Planning Commission

Regular Meeting Agenda
August 12, 2024 | 6:30 PM
Peachtree City City Hall

SUBJECT: Conceptual Site Plan and Building Elevations, Take 5 Oil & Coffee Shop, 2714 HWY 54 W

SUBJECT: Landscape Plan, Gerresheimer, 650 HWY 74 S

PROJECT NO.: TAK02200570
DATE: 7/9/24
SCALE: AS NOTED
DRAWING SERIES: SITE
SHEET NO. C-1.0

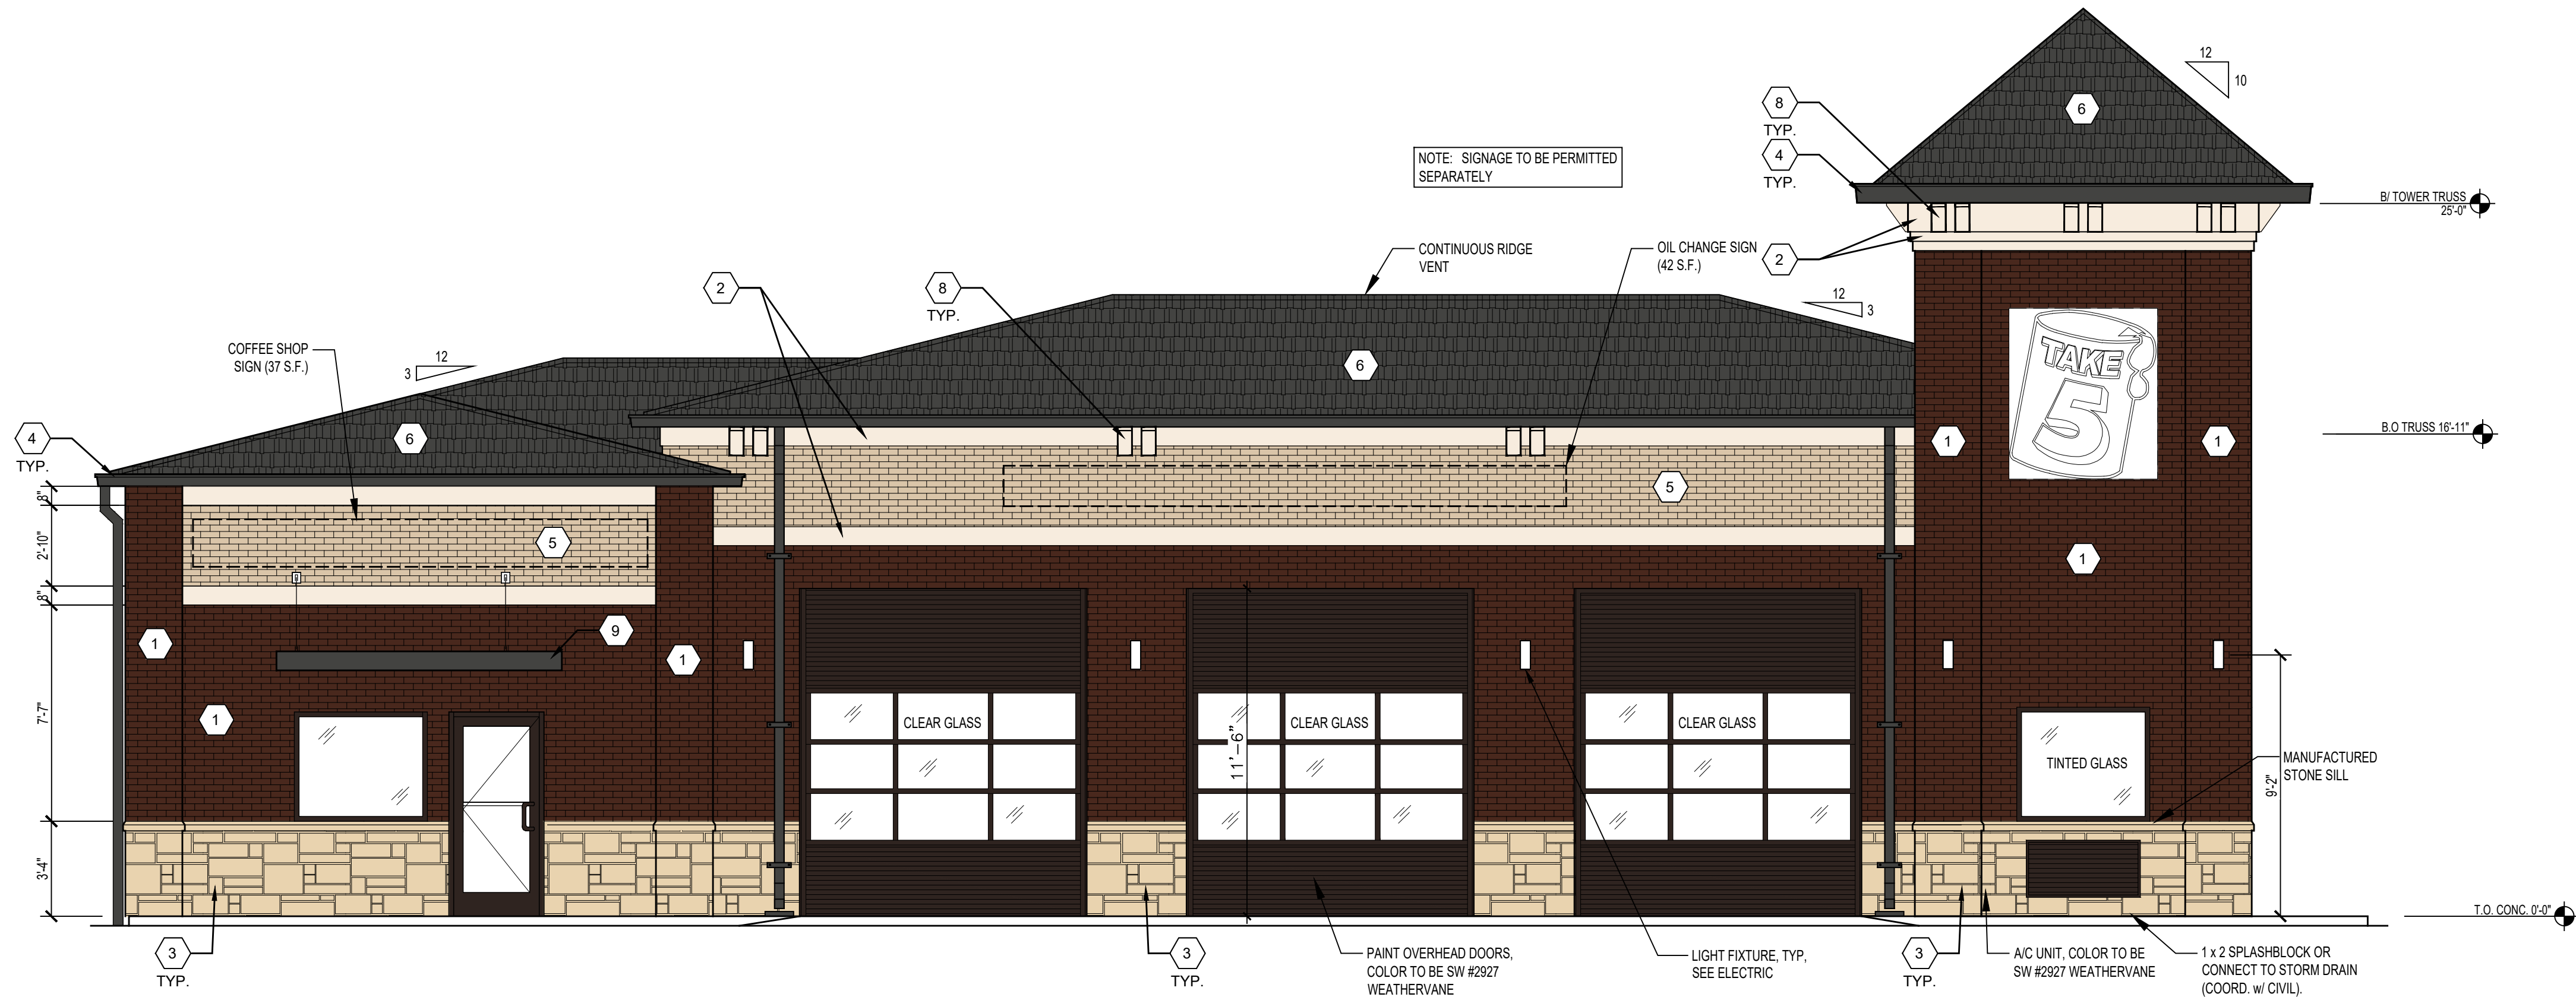
The modifications to the site plan include the following:

- extended entry drive
- smaller building area for Take 5
- coffee shop added to the east end of the building
- drive-thru lane for coffee shop

There are no changes proposed for the building placement or the general location of the parking.

A shared access easement was required between the parcel owner and the City to allow the shared driveway that straddles the west property line. The existing easement is approximately 80 feet long. An extension of the easement to 195 feet was approved by the City Council August 1, 2024, which will accommodate the modified site layout.

Staff is of the opinion that the proposed plan and building elevation modifications meet the City ordinances and the GA 54 West Design Guidelines and recommends approval.

1 FRONT ELEVATION
A-200 1/4"=1'-0"

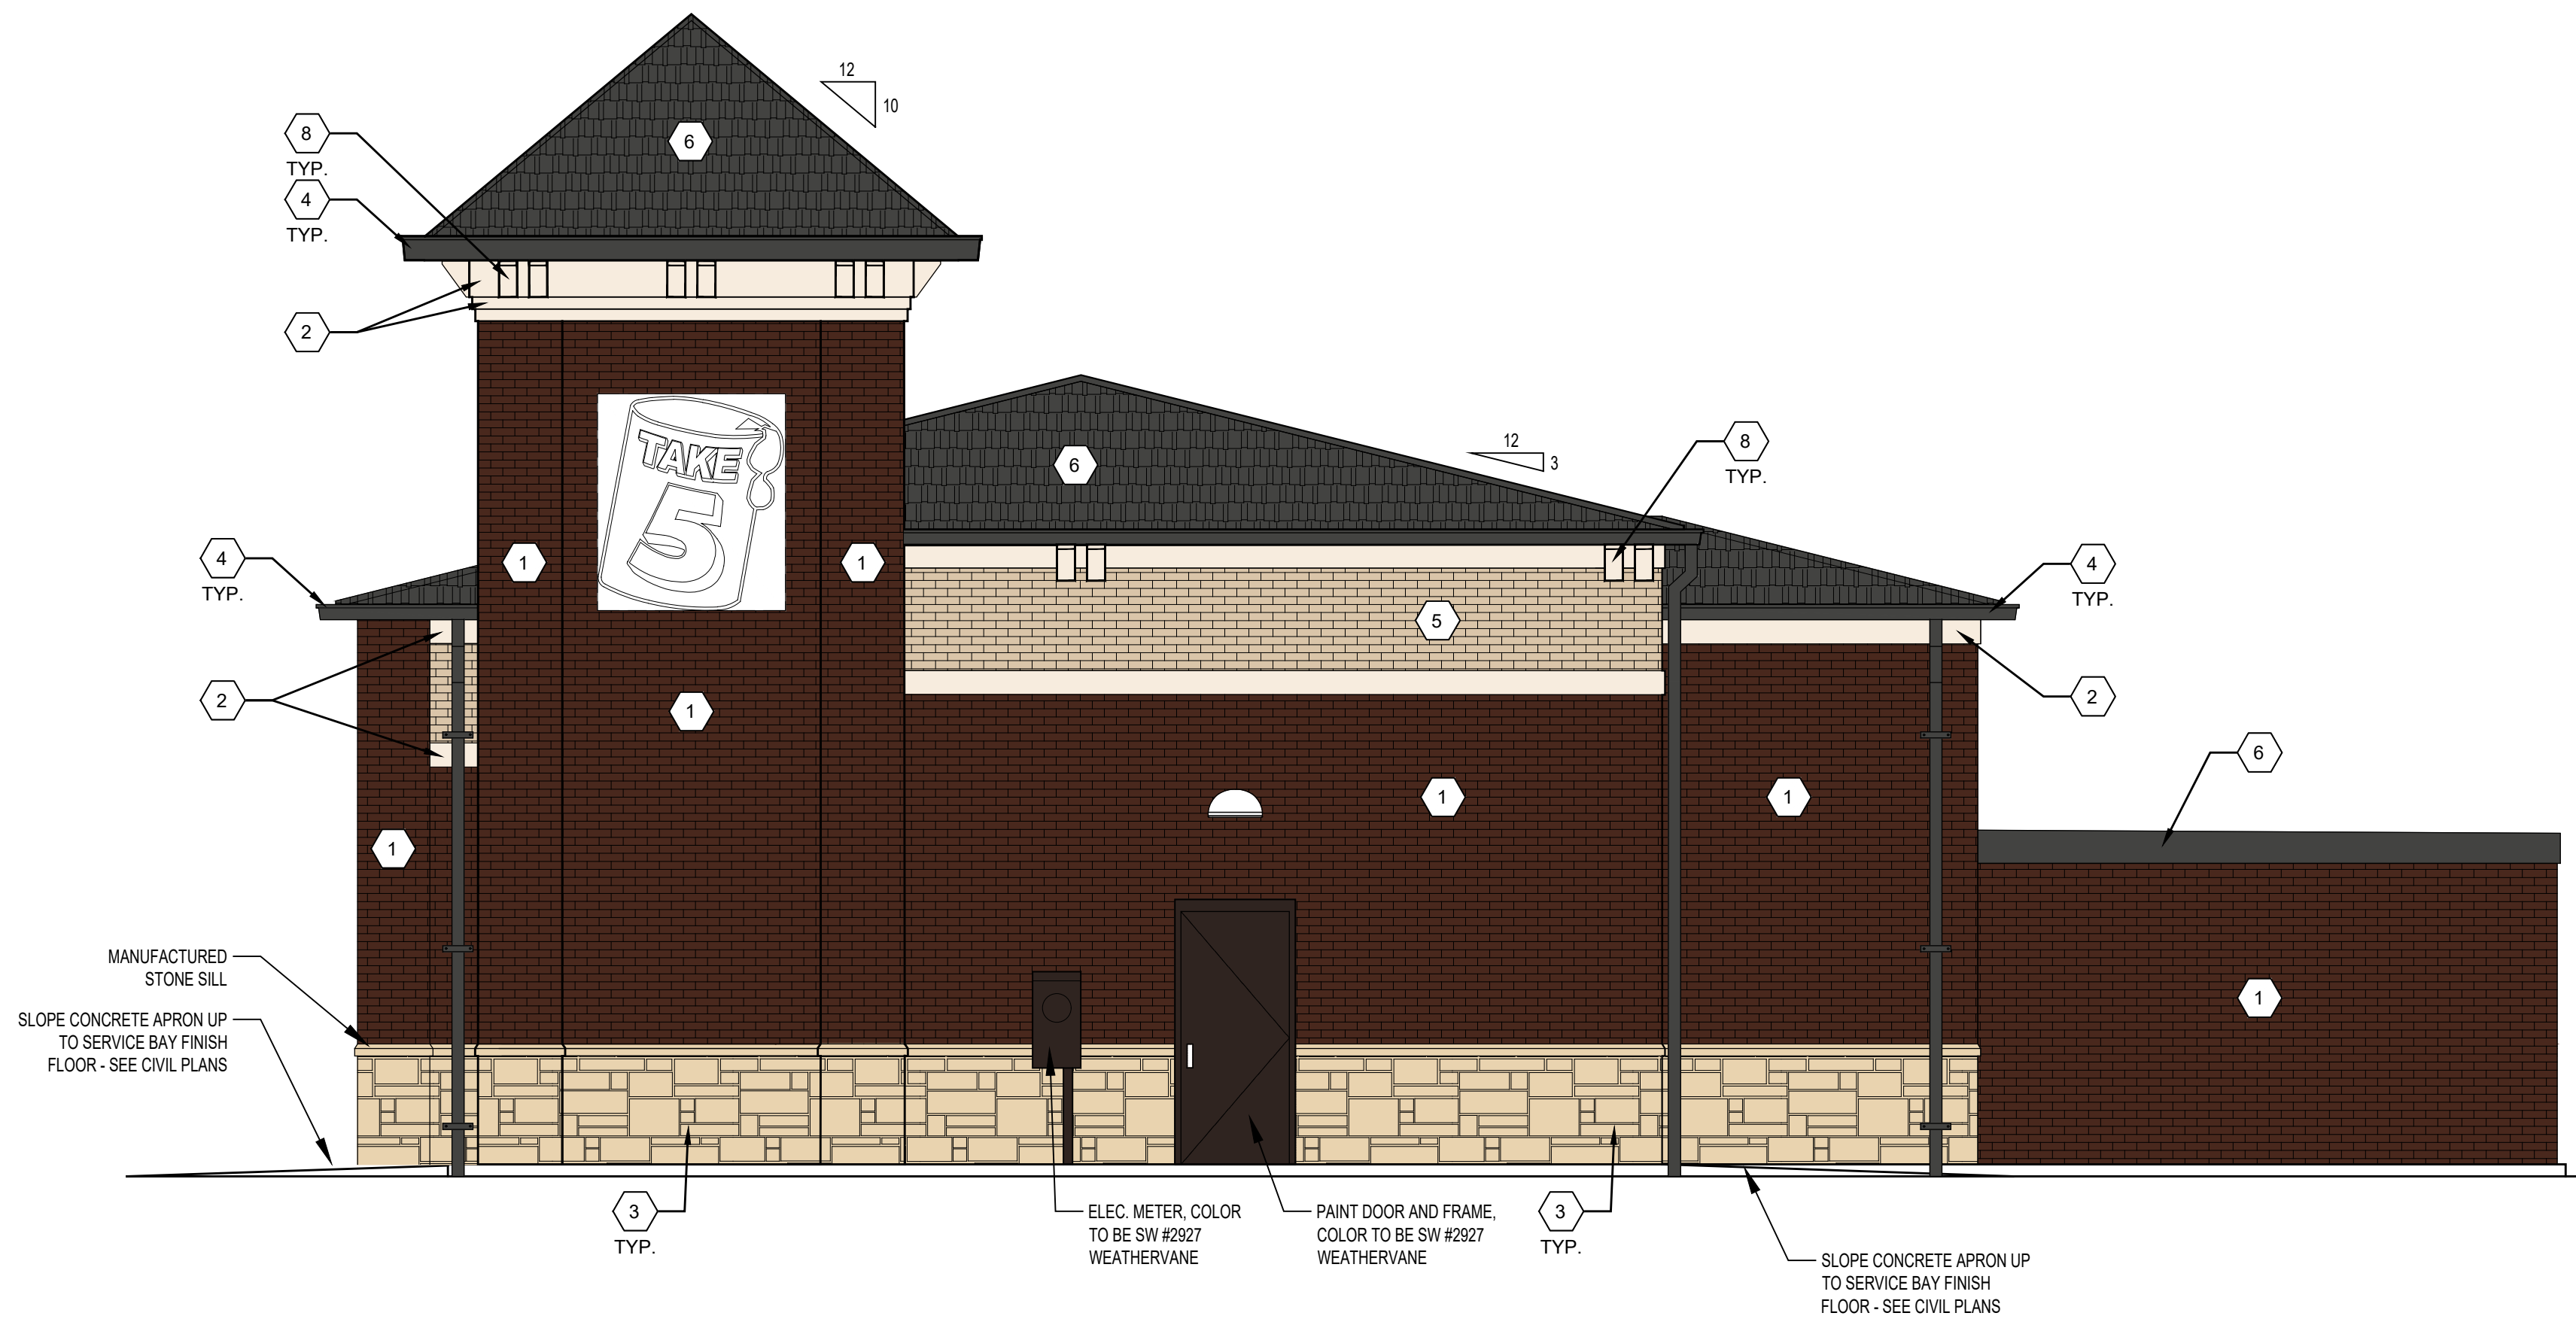
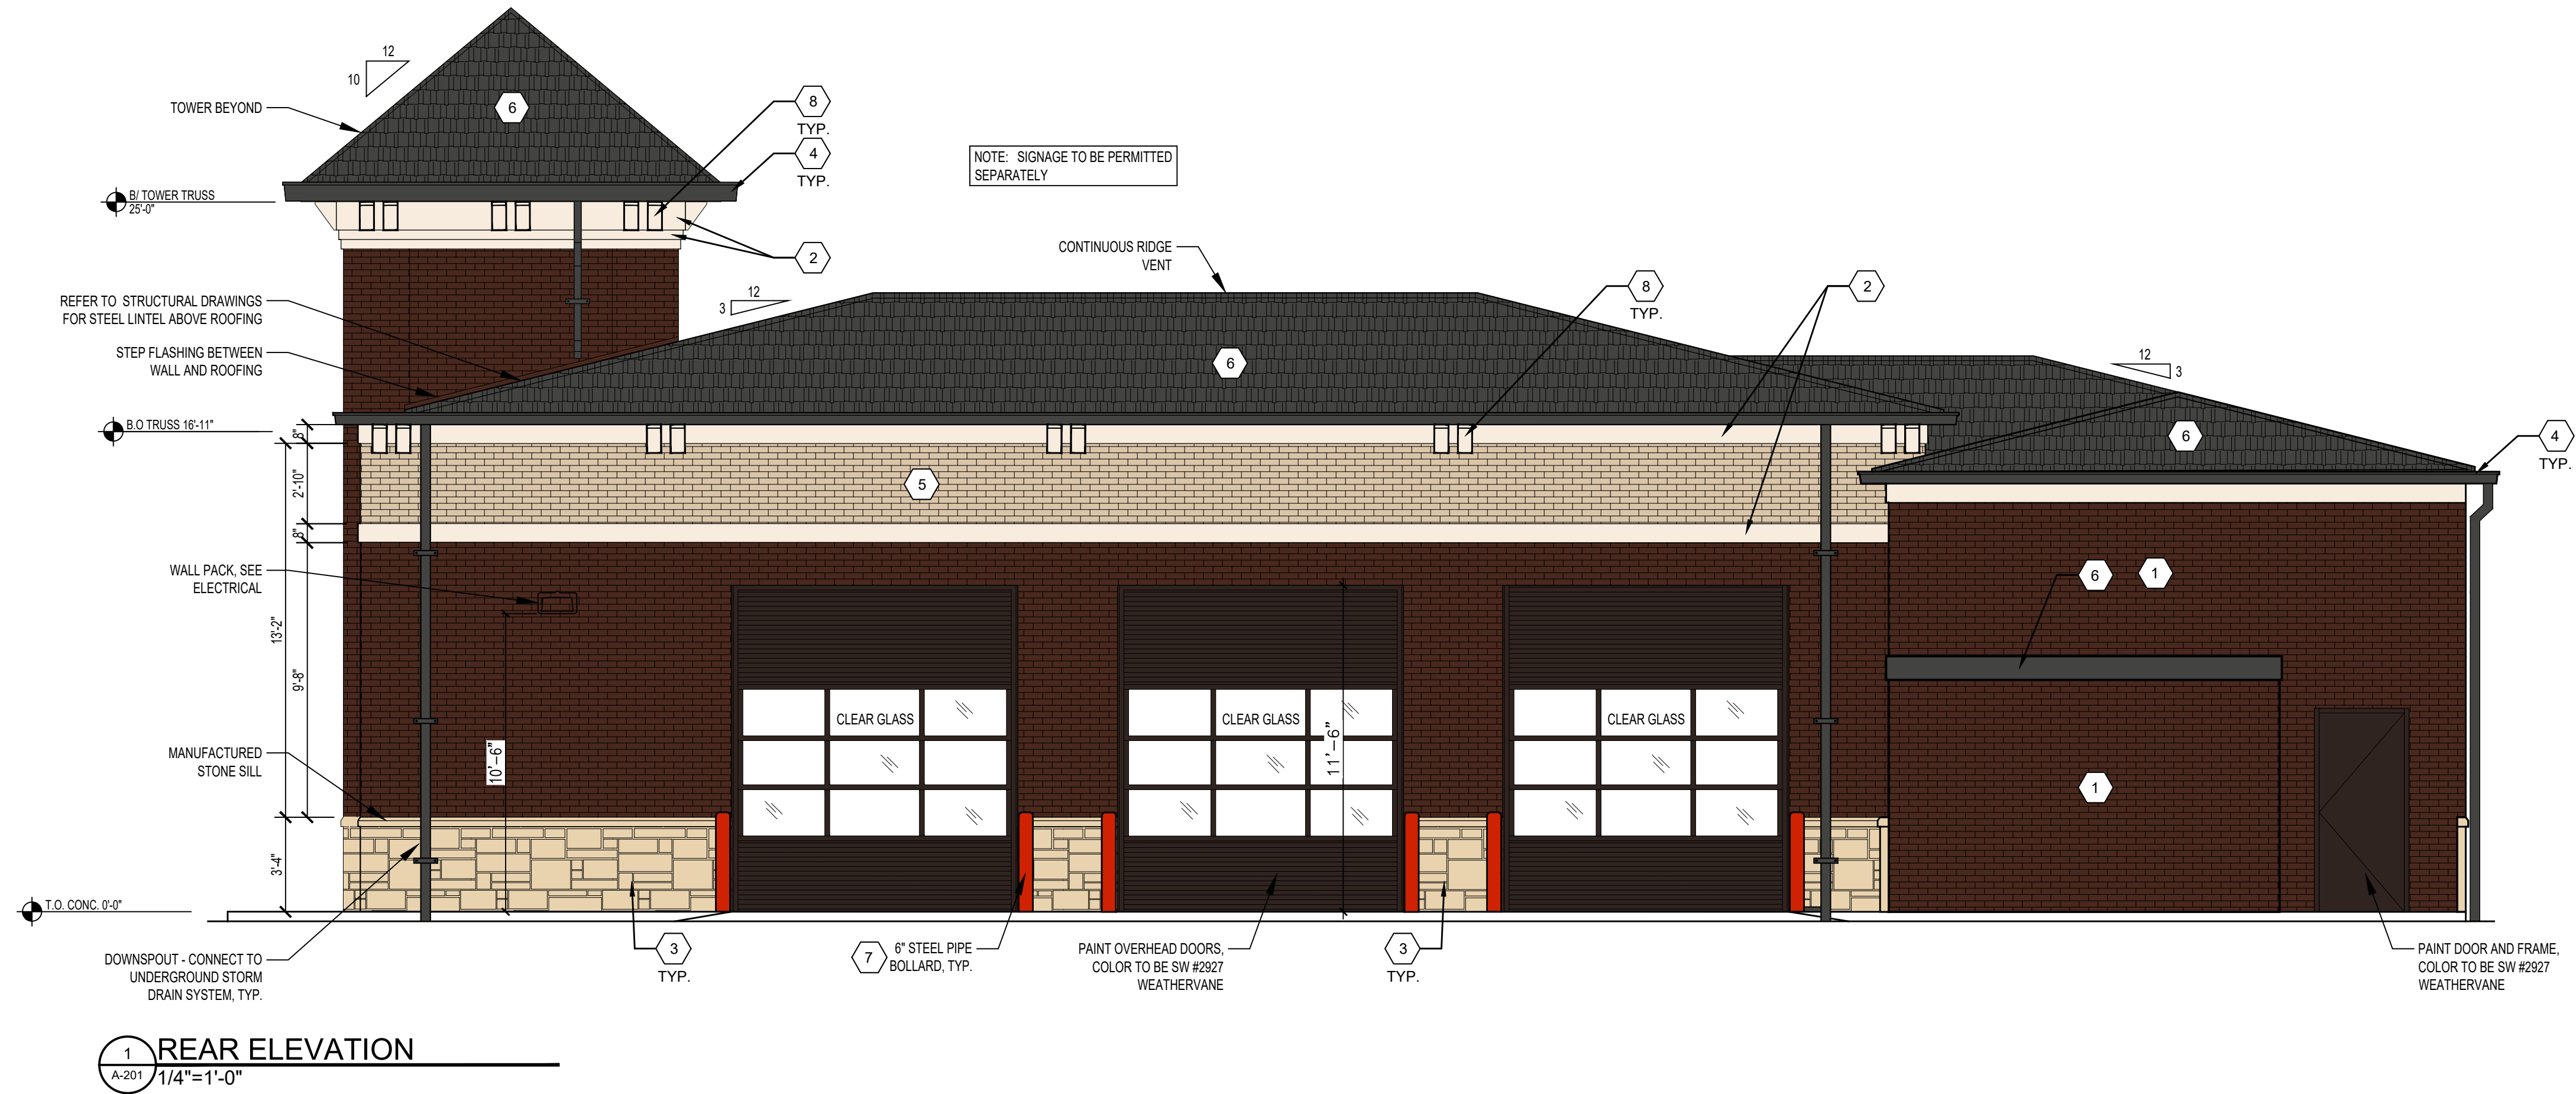
The proposed building elevations are very similar to the approved elevations. The secondary brick has been changed from Portsmouth, a reddish colored brick by Triangle Brick Company, to Ansley Park, a buff colored brick by Cherokee Brick. The Design Guidelines specify Medium Buff by Acme Brick, which is no longer available, or something similar for an accent brick. Since Ansley Park is a buff color, staff feels it is an acceptable replacement.

The only other proposed change is the roofing material. Instead of the approved charcoal gray, standing seam metal roof, an architectural asphalt shingle roof of the same color is proposed. Asphalt shingles are permitted by the Design Guidelines.

The proposal includes the following color palette (the changes are highlighted in bold):

- Primary Brick - Triangle Brick Company, Cambridge
- **Accent Brick - Cherokee Brick, Ansley Park**
- Stone Wainscot - Reading RockCast, Creme Buff
- Accent Moulding - Aztek Exterior Trim, Soft White
- **Roof - GAF Timberline HDZ Shingles, Charcoal**
- Trim and misc. - painted Sherwin-Williams #2927, Weathervane
